**Project Title:** Emergency Generator Installation  
Building 56  
Central Experimental Farm (CEF), Ottawa (Ontario)

**Solicitation No:** 13-1427

March 3, 2014

## Addendum 1

title:  
 TYPICAL PROTECTIVE BOLLARD DETAIL

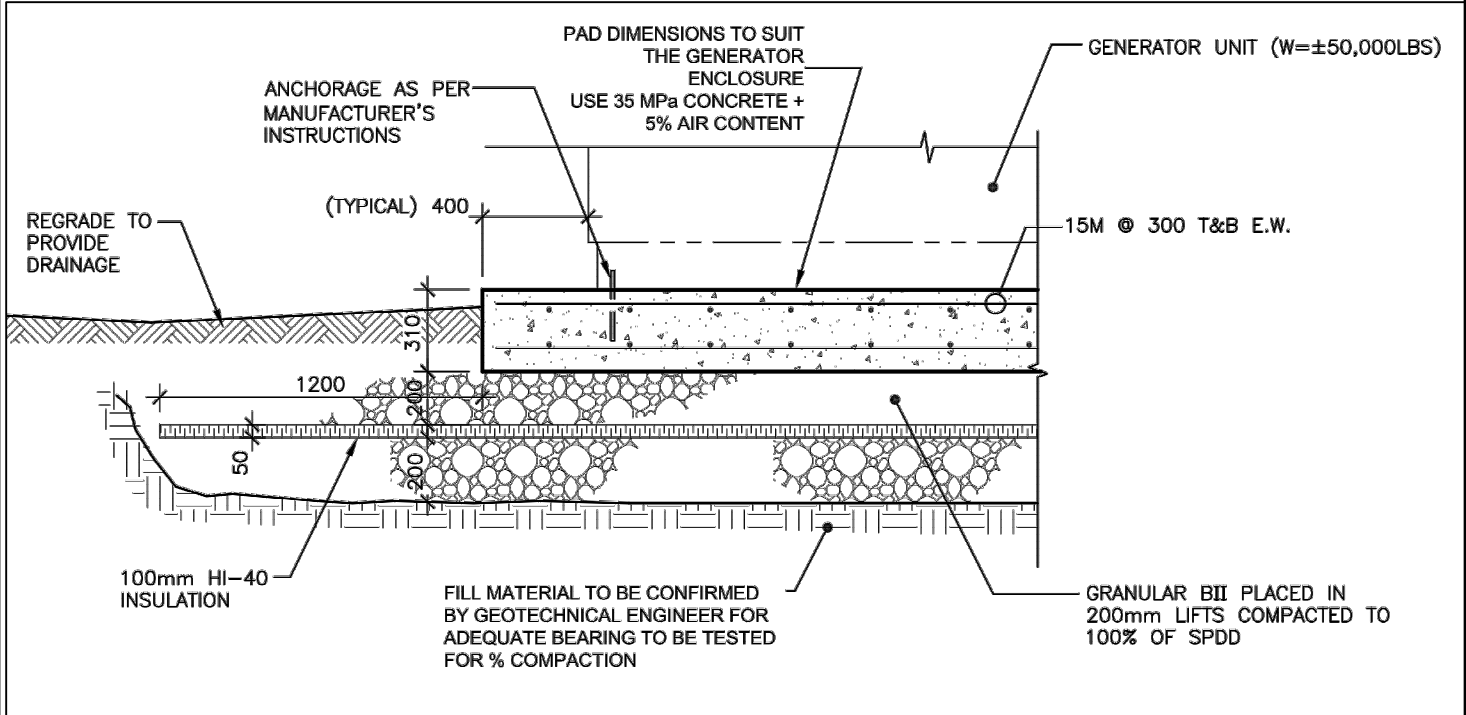
**Q12. Can you provide all details regarding the concrete slab and the bollards?**

**Add:** ESK-01 Typical Protective Bollard Detail

**1. At Drawing E100 “Site Plan and Generator Details, Note 7:**

**Delete:** 200mm diameter galvanized steel bollard.

A12. Yes, see included ESK-1 and ESK-2 Drawings.

**Replace with:** The Contractor shall provide 200mm diameter protective concrete filled steel bollards around enclosure’s concrete slab as shown. Refer to ESK-01 Drawing for bollard details.
